# UNITED STATES PATENT AND TRADEMARK OFFICE

APPLICATION NO.	FILING DATE	FIRST NAMED INVENTOR	ATTORNEY DOCKET NO.	CONFIRMATION NO.
10/596,694	06/20/2007	Angelo D'Arrigo	78857.105667	9542
86528	7590	11/13/2009		
King & Spalding LLP 401 Congress Avenue Suite 3200 Austin, TX 78701			EXAMINER GORDON, BRYAN P	
			ART UNIT 2837	PAPER NUMBER
			MAIL DATE 11/13/2009	DELIVERY MODE PAPER

### Office Action Summary

### **DETAILED ACTION**

**Figure A**

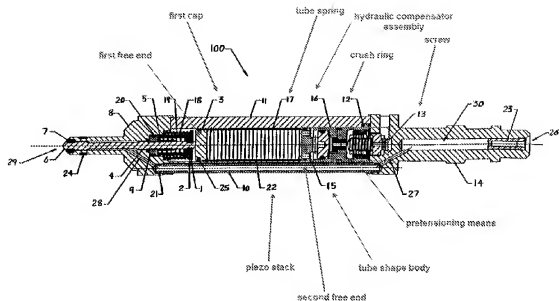
6. Considering claims 1 and 10, Shen (Figure A) teaches a piezoelectric actuator unit comprising: a tube spring (17); a piezoelectric actuator (22), that is inserted into the tube spring, a first cap (3), that is connected to the tube spring at a first free end (See Figure A above) of the tube spring and which is adjoined by the piezoelectric actuator (22), a tube-shaped body (15) that is connected to the tube spring by joining and is arranged in the area of a second free end (see Figure A), and a means for pretensioning the piezoelectric actuator after the tube spring (17) is connected to the first cap (3) and the tube-shaped body (15) (col. 3 lines 7-15, the device is already together therefore all the parts are connected) the means for pretensioning being supported by the tube-shaped boy (col. 5 lines 52-54), and pretensions the

piezoelectric actuator (col. 5 lines 49-57) by physically compressing the piezoelectric actuator (22) but not the tube-shaped body.

7. Considering claims 4 and 13, Shen (Figure A) teaches a thread in the tube-shaped body and wherein the pretensioning means is a screw (13) that is screwed into the thread.

Figure B

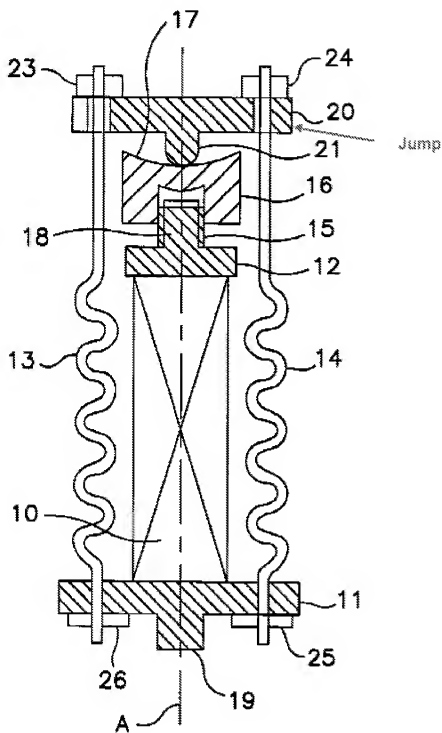
14. Considering claims 6 and 15, Mattes (Figure 1) teaches the tube-shape body has a jump in its diameter on its outer circumference.
